TRANSMITTAL COVER SHEET

DATE: 21 June, 2024
TO: ALL PLAN HOLDERS OF RECORD
FROM: HUNTER SWATEK, AIA, PROJECT MANAGER
PROJECT: RAINBOW CITY RECREATION CENTER
GMC PROJECT NO. ABHM230021
RE: ADDENDUM NO. 3 AND
ACKNOWLEDGEMENT OF RECEIPT OF ADDENDUM NO. 3

ADDENDUM NUMBER 03

**PROJECT: RAINBOW CITY RECREATION CENTER
GM&C PROJECT NO. ABHM230021**

SECTIONS
S3.04

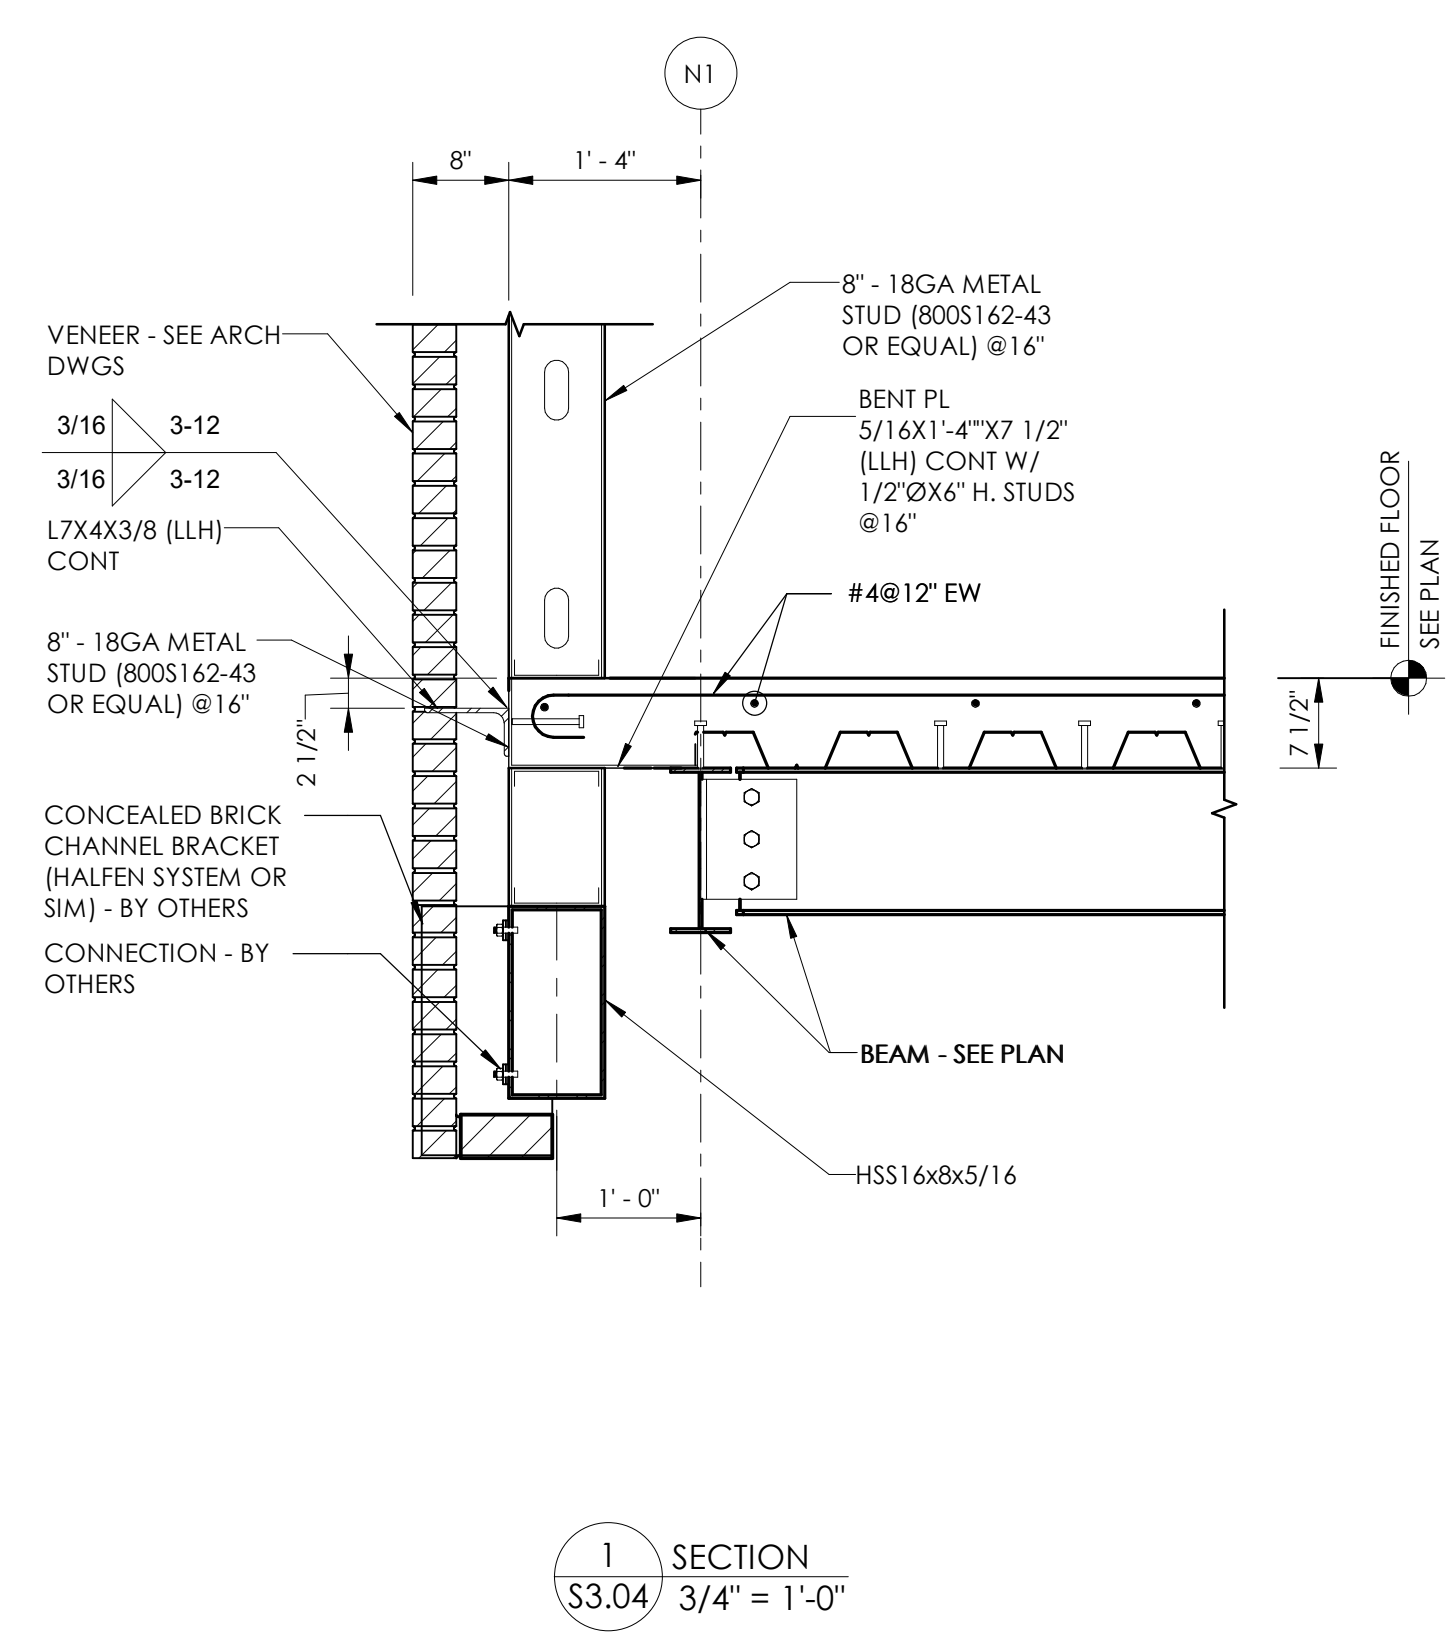
- a. ADDED Sections
- Y. **S3.02** – Sections
 - a. REVISED Angle size
- Z. **S3.03** – Sections
 - a. REVISED Angle size
- AA. **S3.04** – Sections
 - a. REVISED Sizes
